**STAFF REPORT  
KETCHUM PLANNING AND ZONING COMMISSION  
REGULAR MEETING OF JULY 11, 2023**

**PROJECT:** Pratt Residence

**FILE NUMBER:** P23-009 and P23-009A

**APPLICATION TYPE:** Mountain Overlay Design Review and Conditional Use Permit

SITE DISTURBANCE DIAGRAMS  
SCALE: 1" = 10'

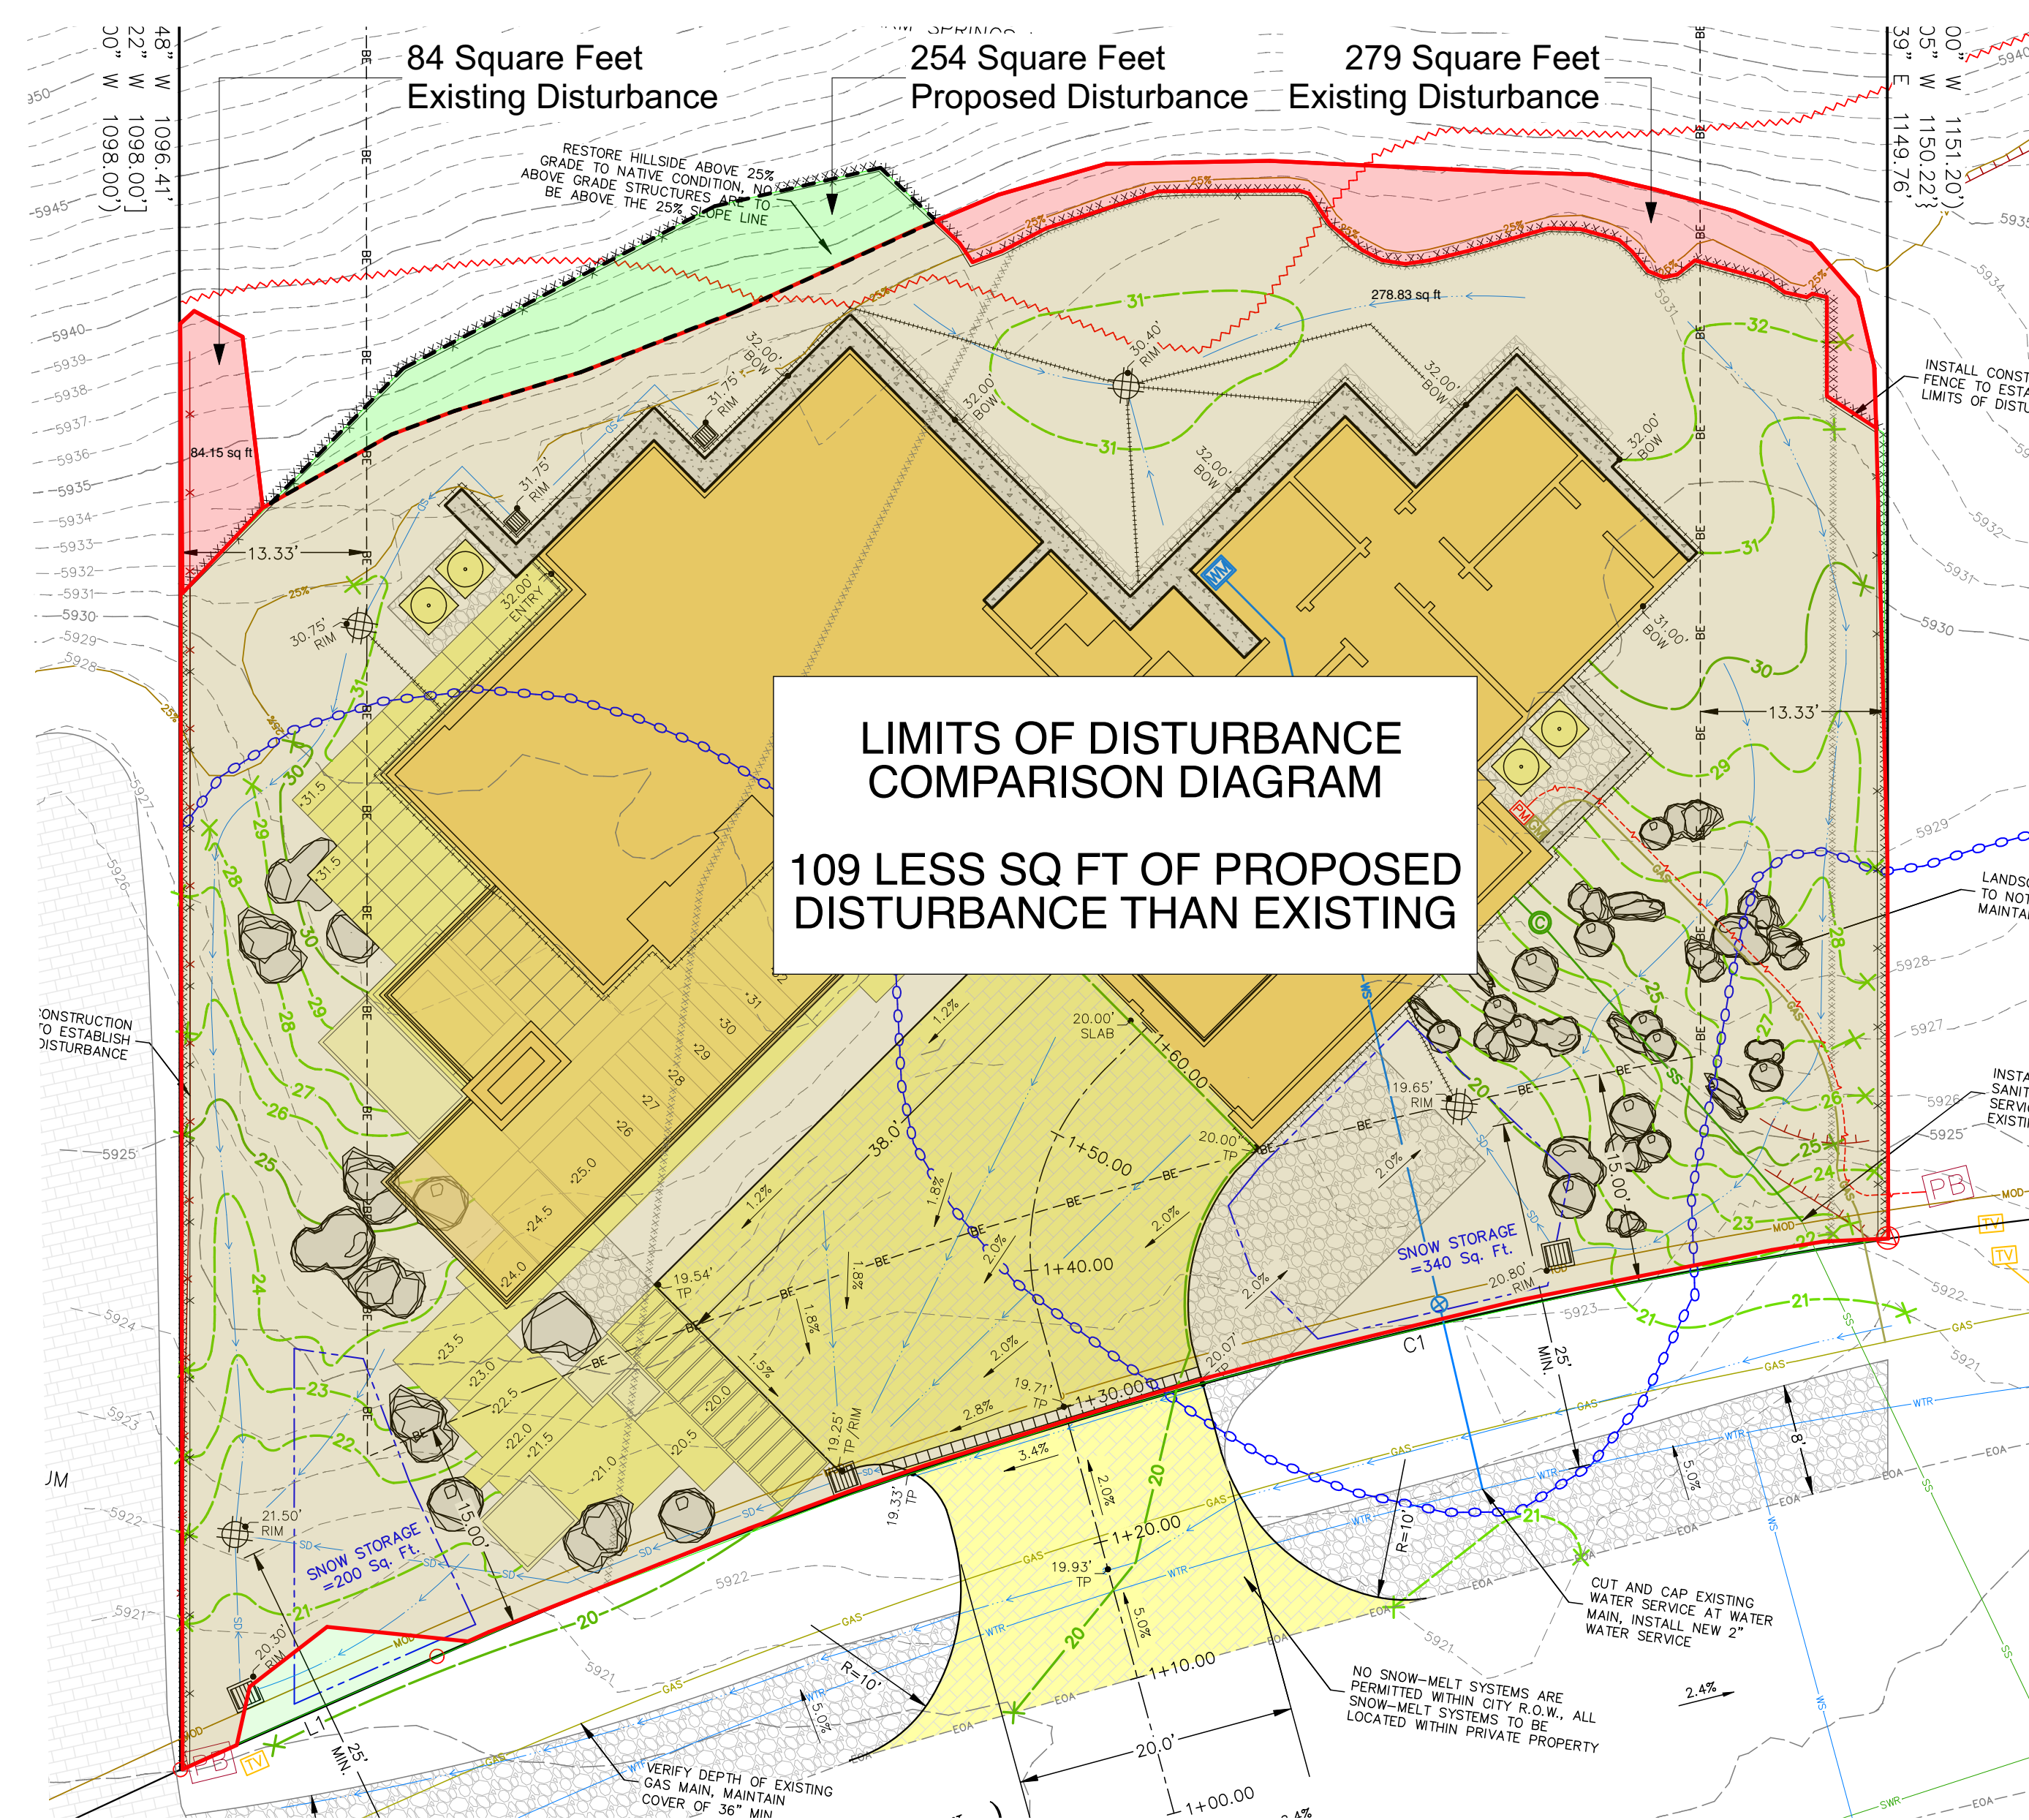
encroach into the 25% slope area. However, 396 square feet of disturbance into the hillside is proposed for the structure's construction. This disturbance is not reflected in the current plan set, as staff had brought it to the applicant's attention that the existing limits of disturbance diagram on Sheet A200C of Attachment B had not accurately reflected the site survey. The applicant informed staff that an outdated site survey had been used and sent staff a revised Sheet A200C which increased the proposed limits of disturbance from 254 square feet to 396 square feet. The MOD does encourage development to be sited down on the hillside, which the proposed residence does by having just slightly above the minimum required front yard setback. However, as the development uses more of the western portion of the lot, the development does see encroachment into the 25% slope area. In previous Mountain Overlay applications, the Commission has been supportive of minor encroachments into the 25% slope area for permanent structures. The project is proposing temporary encroachment into the 25% slope for construction that would be reclaimed following completion of the project. Therefore, staff is supportive of the proposed temporary encroachment into the hillside.
